2017 Taranaki Airspace Review

Final airspace changes

Figure 1 – new GAA NZG351 Egmont

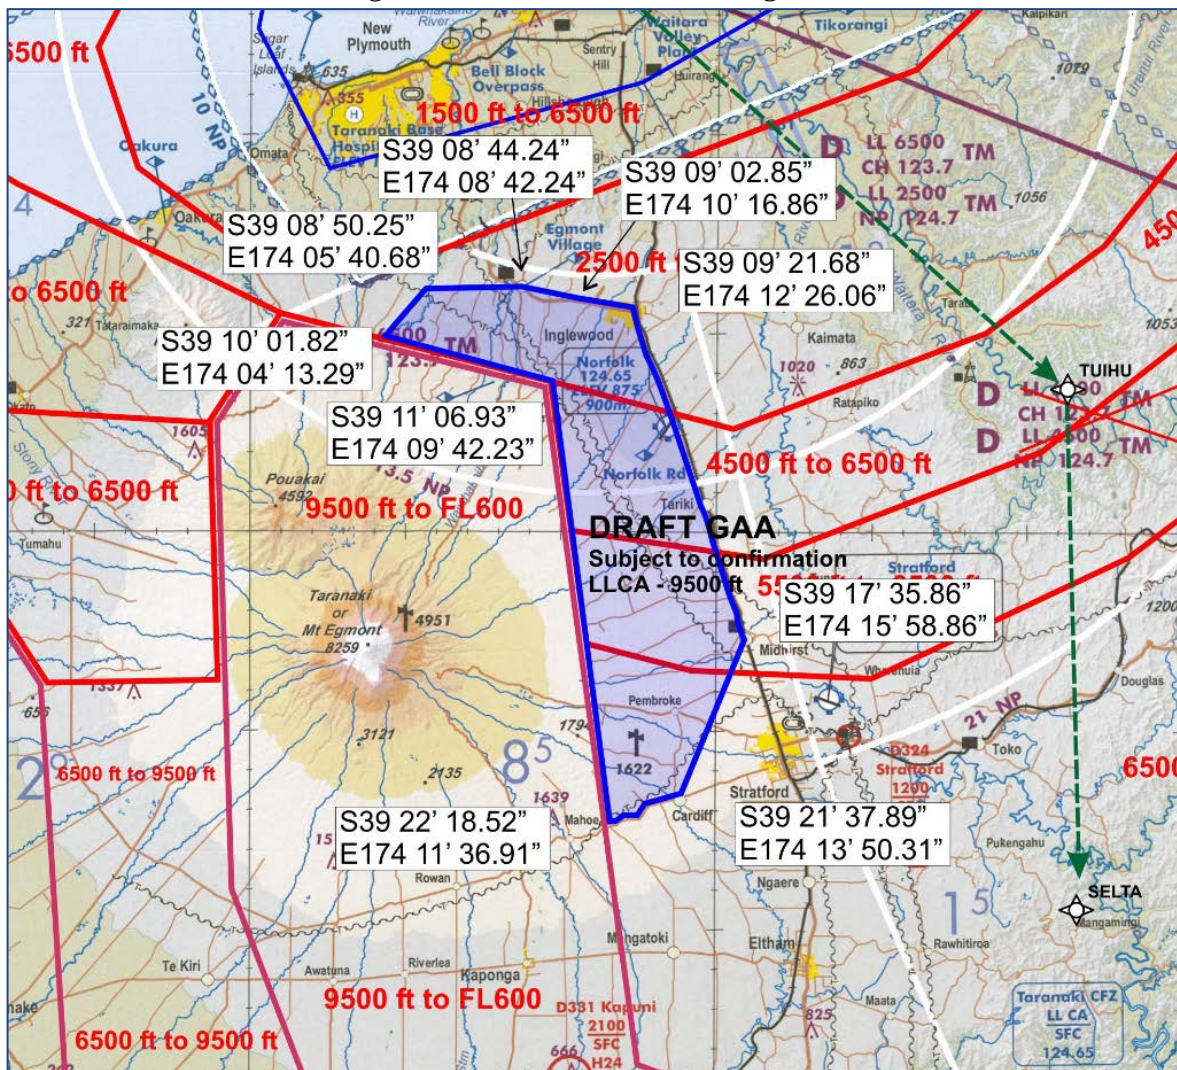
'RWY 05 procedures were not considered in the draft GAA design, and in fact would require significant extra track miles and delays for all arrivals from the south, as all traffic would need to track overhead NP and join the approach from the northwest. This would put those flights in conflict with arrivals from the north as well, resulting in regularly occurring delays.

- As the GAA is not feasible for use when RW05 is in use, having it activated by notification is also unfeasible, and any GAA would need to be by ATC approval for this reason alone.*
- The restrictions posed on both PBN and conventional traffic (see below), and the added complexity for the NP TWR controllers, may be acceptable when considering the GAA should be in use approximately 25 afternoons per year, probably on weekends. However, if it were used significantly more than that this would be an entirely more difficult proposal.*

- *Significantly, as the GAA has only been considered for use when RW23 is in use, there must be some mechanism in place to close the area when needed, and have an assurance that the area is vacant when it is closed, in the event of a wind (and therefore, runway) change. In the absence of such an option, the GAA would have to be denied whenever the possibility exists of a westerly wind changing to easterly throughout the day.*

Whilst Airways believe we can operate to avoid the GAA, the restrictions on other traffic, workload on the tower and extra risks involved (especially around whether the GAA can be closed at short notice in the event of a weather change) may mean that the GAA is denied more often than not.'

NZG351 Egmont will be designated, LLCA to 9500 ft, active by ATC approval only. It is strongly suggested that the Taranaki Gliding Club and Airways establish a memorandum of understanding to clarify conditions of use.
